**Addendum
No. 1**

Date: April 3, 2017
Project: CRSD Charlton School
Locker Room & Toilet Room Renovations

SHEET TITLE
PARTIAL FLOOR PLANS - NATATORIUM

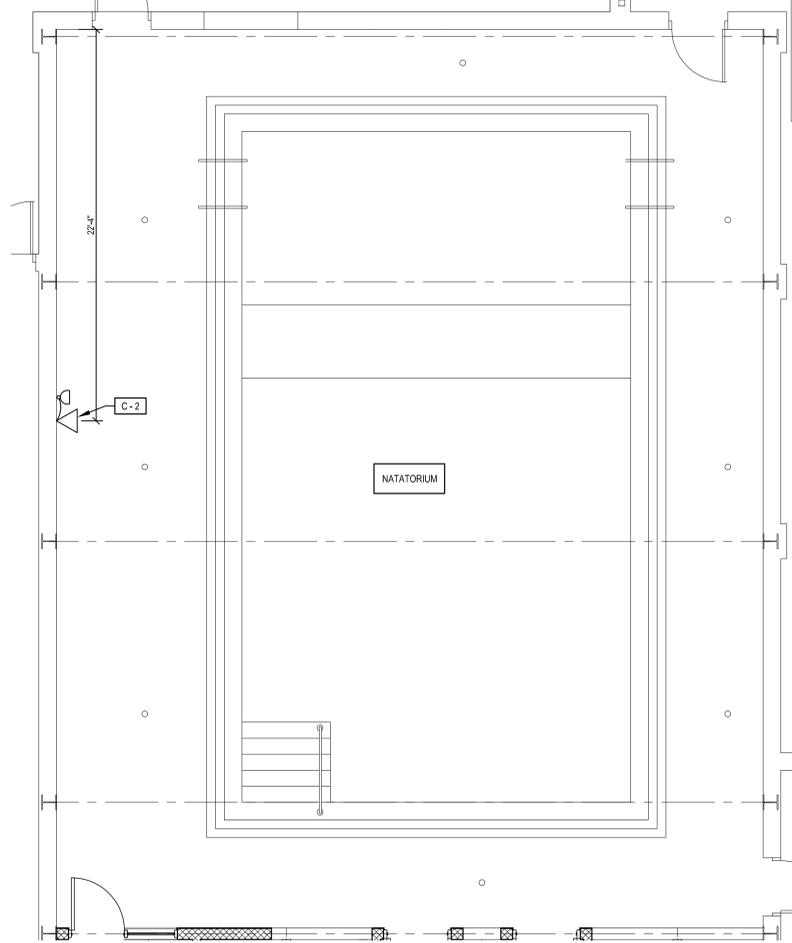
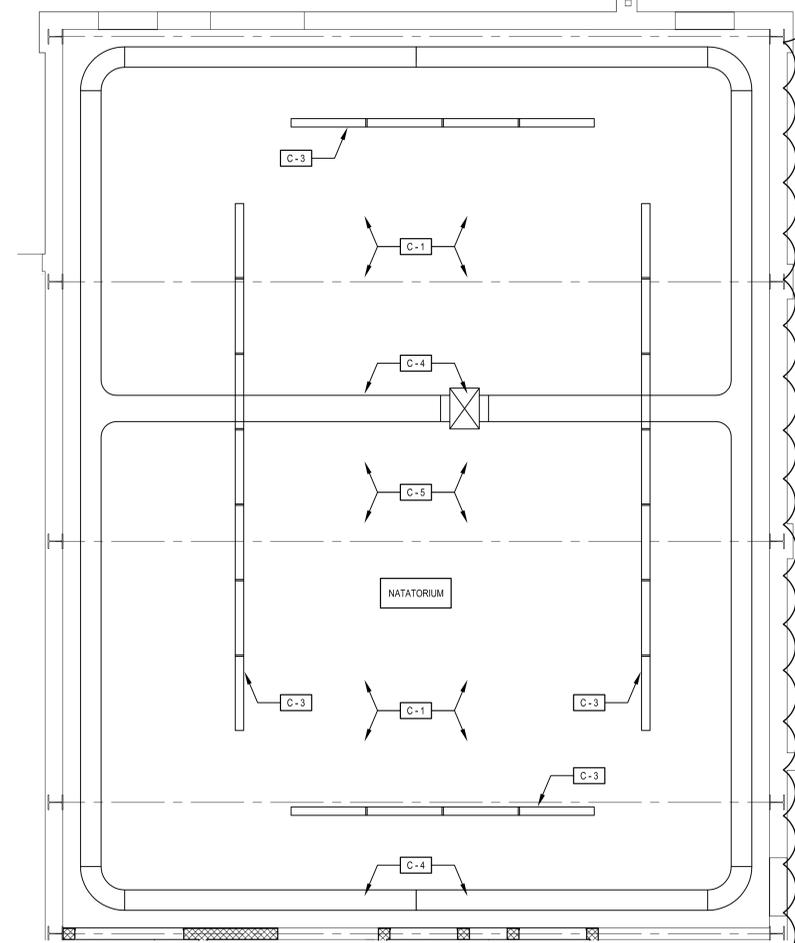
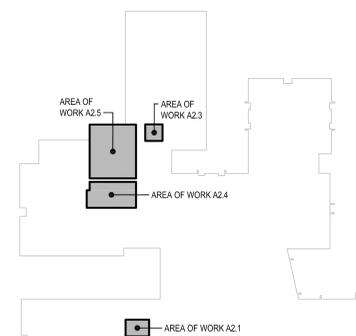
2. Drawing A2.5 – Partial Floor Plans – Natatorium

Revised scope of demolition and new construction.

Added sprinkler scope.

See attached sheet A2.5, Revision 1.

SHEET TITLE
OVERALL ELECTRICAL FLOOR PLAN

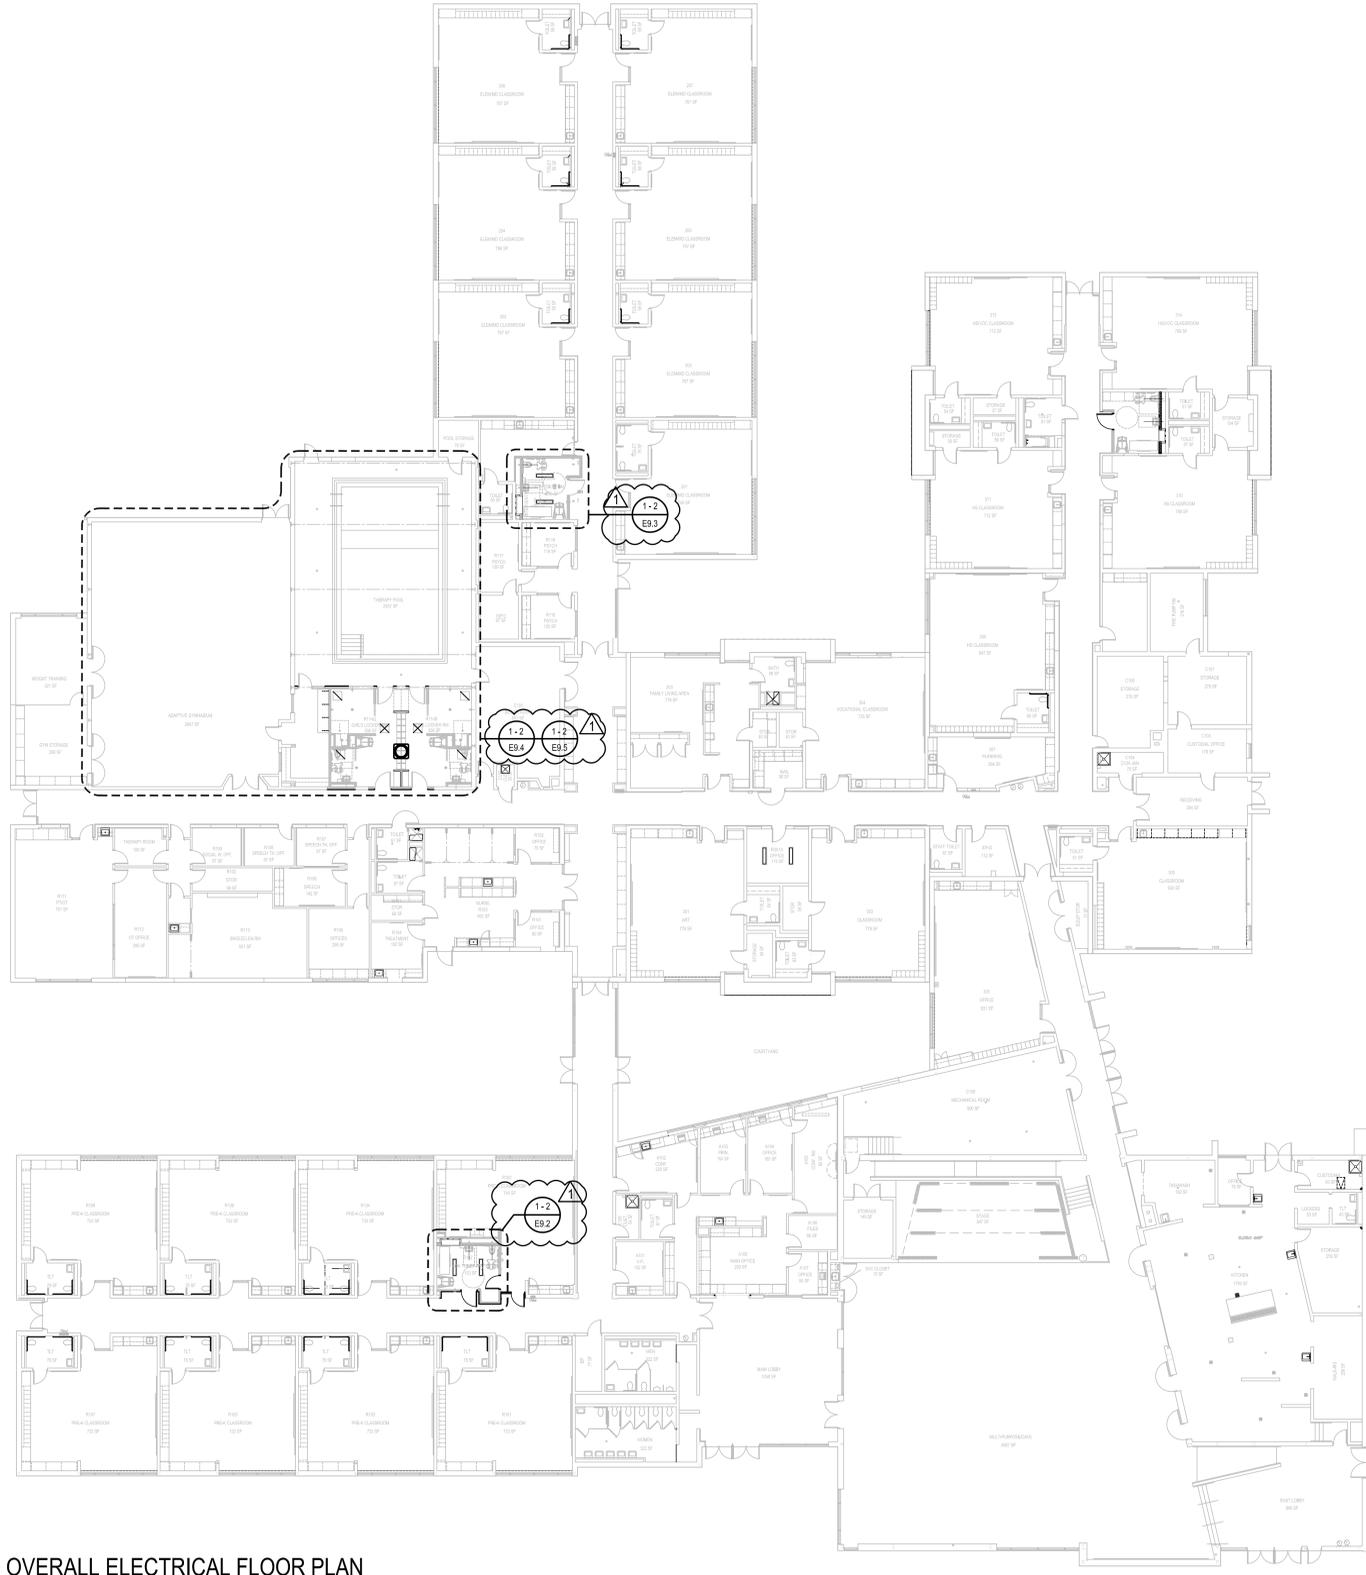
3. Drawing E9.1 – Overall Electrical Floor Plan

Changed the indicated view callouts to have the correct sheet and view numbers.

See attached sheet E9.1, Revision 1.

SHEET TITLE
 PARTIAL ELECTRICAL
 PLANS - R102 & R200

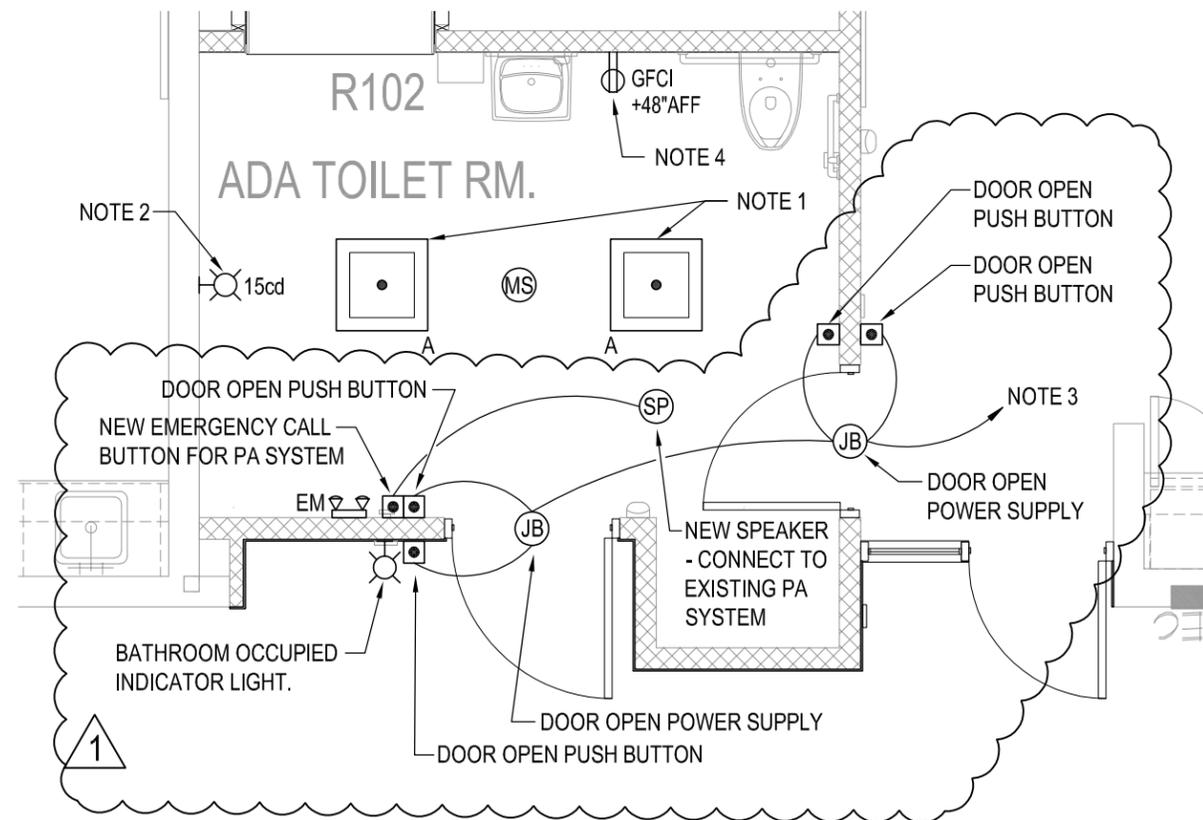
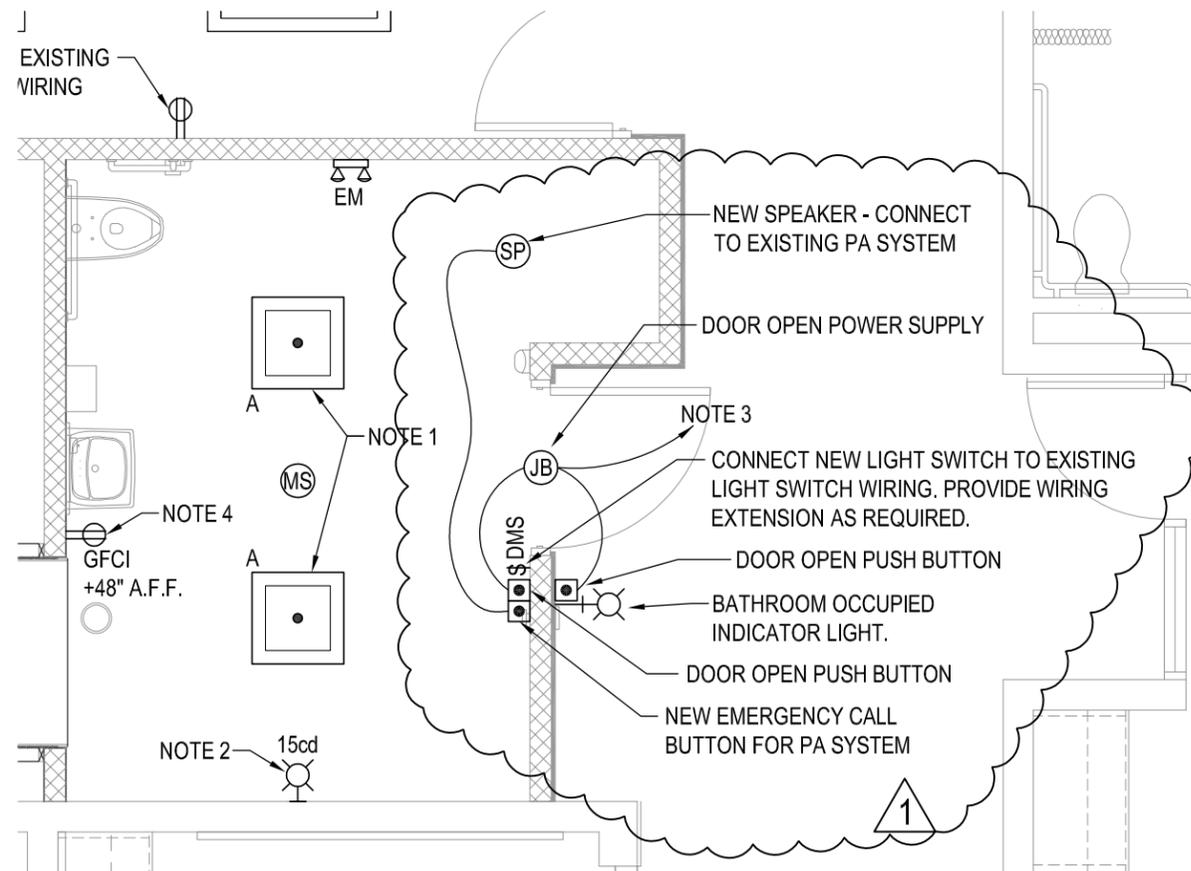
4. Drawing E9.2 – Electrical Floor Plans – R102

Added occupied indicator light, call button, intercom speaker, and labels for all door open push buttons and power supplies.

5. Drawing E9.3 – Electrical Floor Plans – R200

Added call button, intercom speaker, and labels for all door open push buttons and power supplies.

See attached sketch SK-E.1.

See attached sketch SK-E.1.

SHEET TITLE
 MECHANICAL
 DEMOLITION AND NEW
 ROOF PLAN

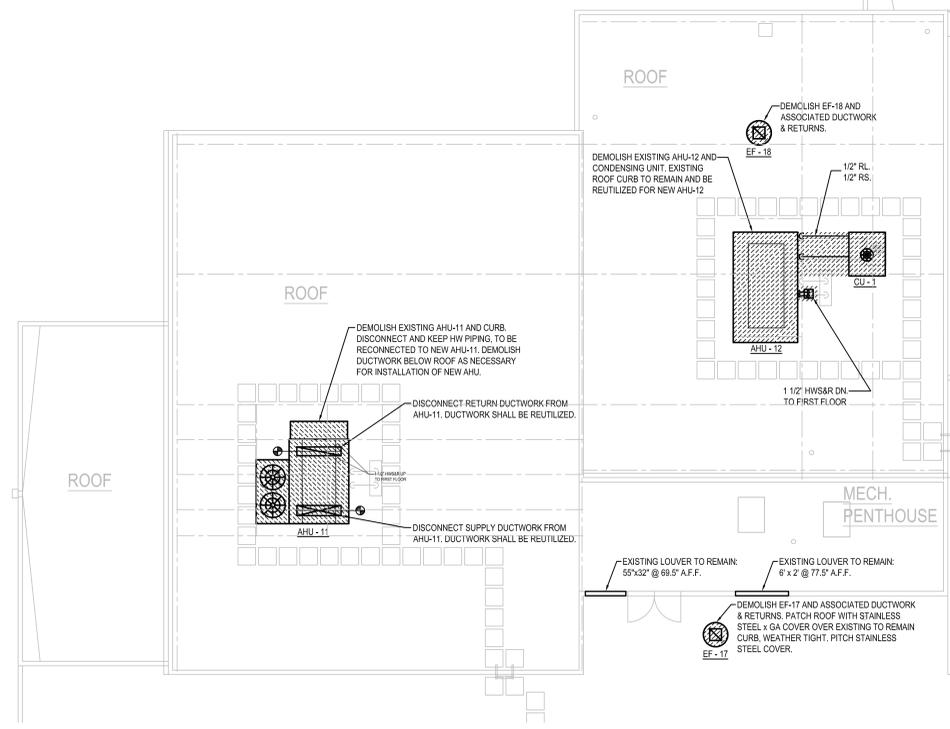
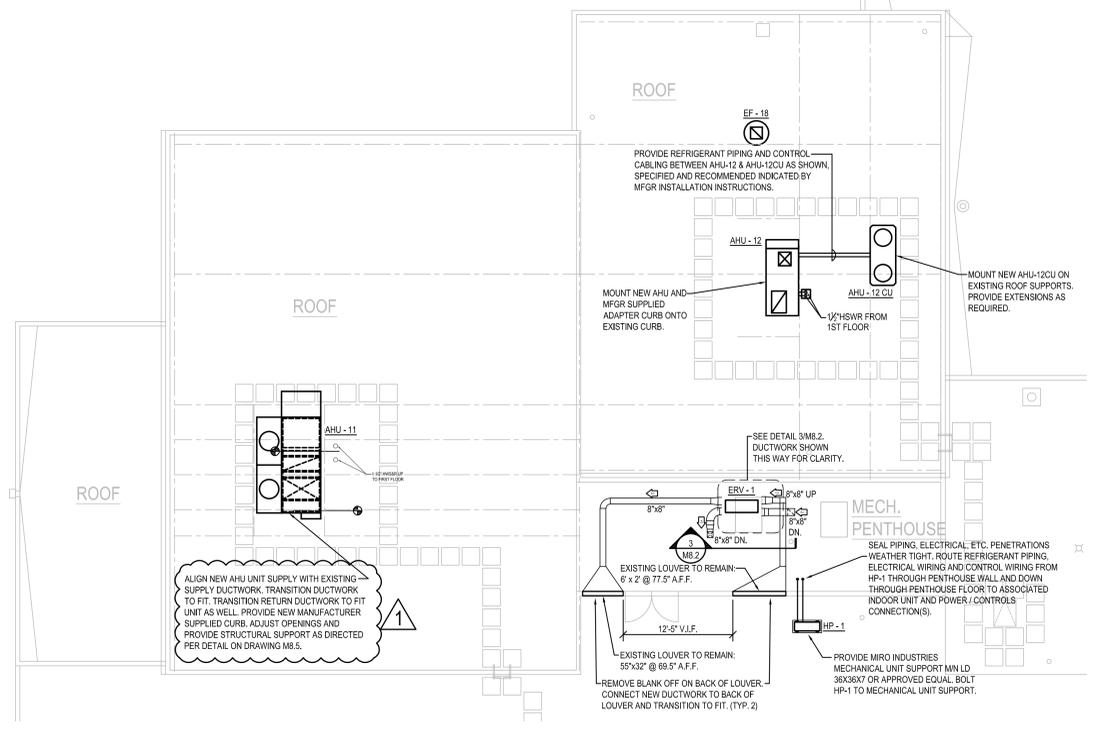
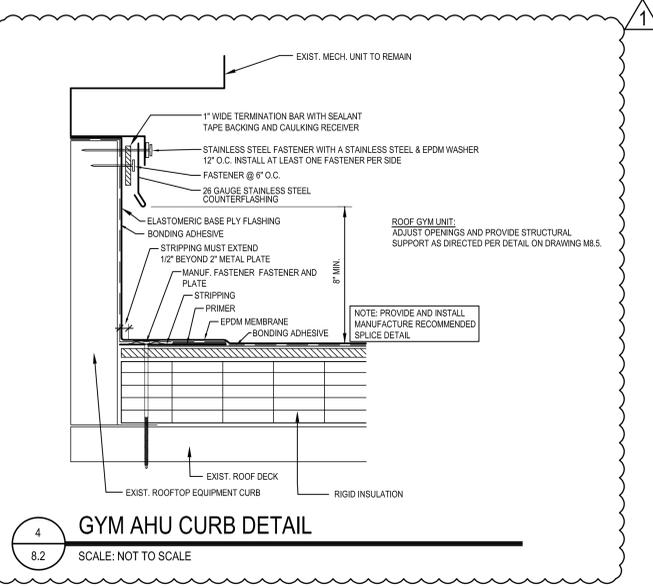
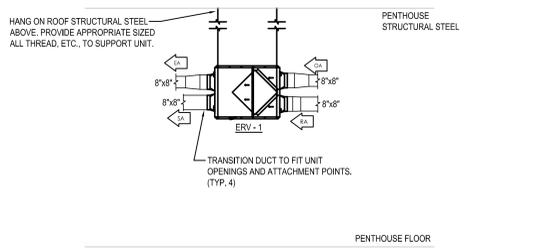
9. Drawing M8.2 – Mechanical Demolition and New Roof Plan

Added structural notation and Roof Curb Detail to new Gym Unit.

See attached sheet M8.2, Revision 1.

MECHANICAL SCHEDULES & DETAILS

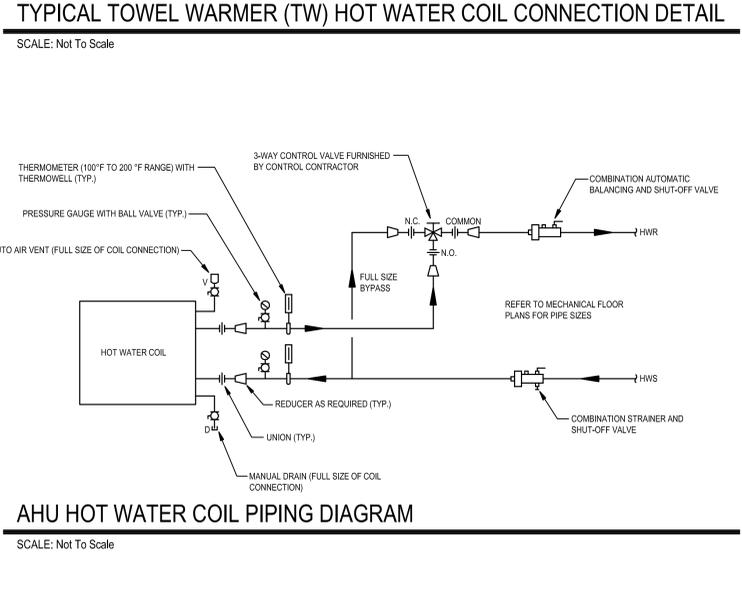
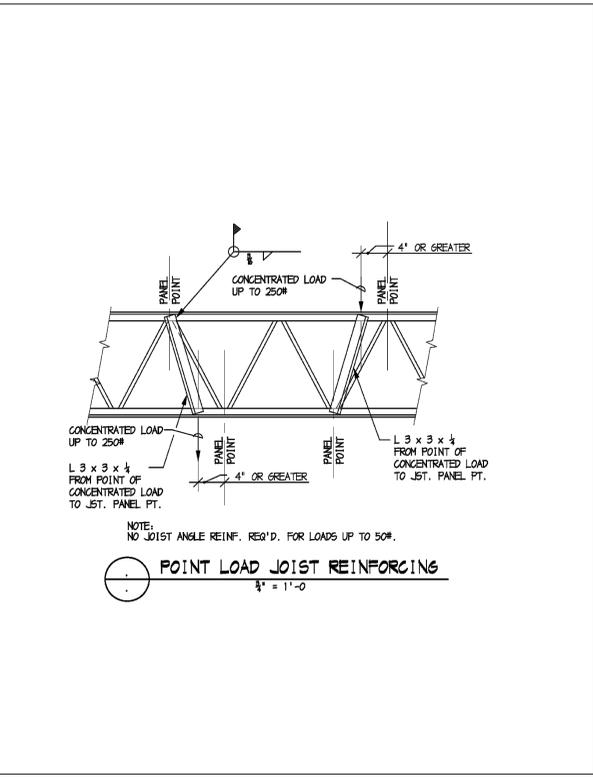
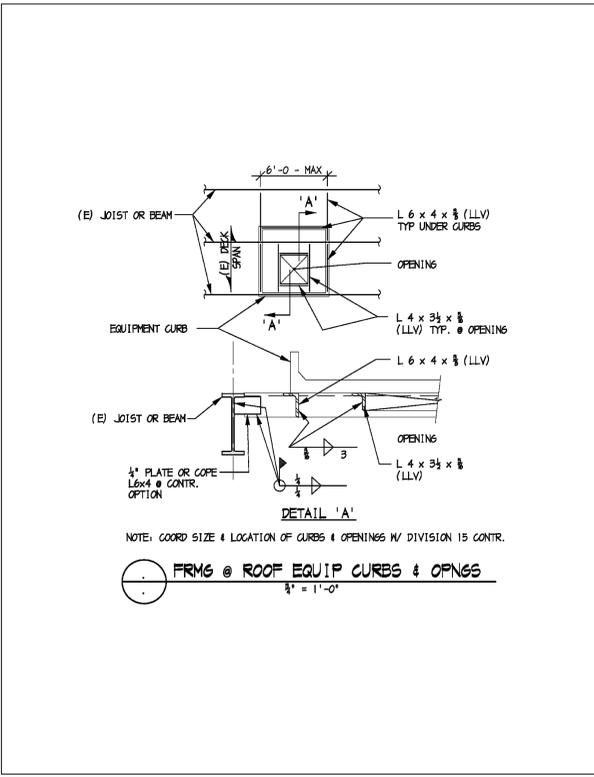
11. Drawing M8.5 – Mechanical Schedules

Modified schedules.

See attached sheet M8.5, Revision 1.
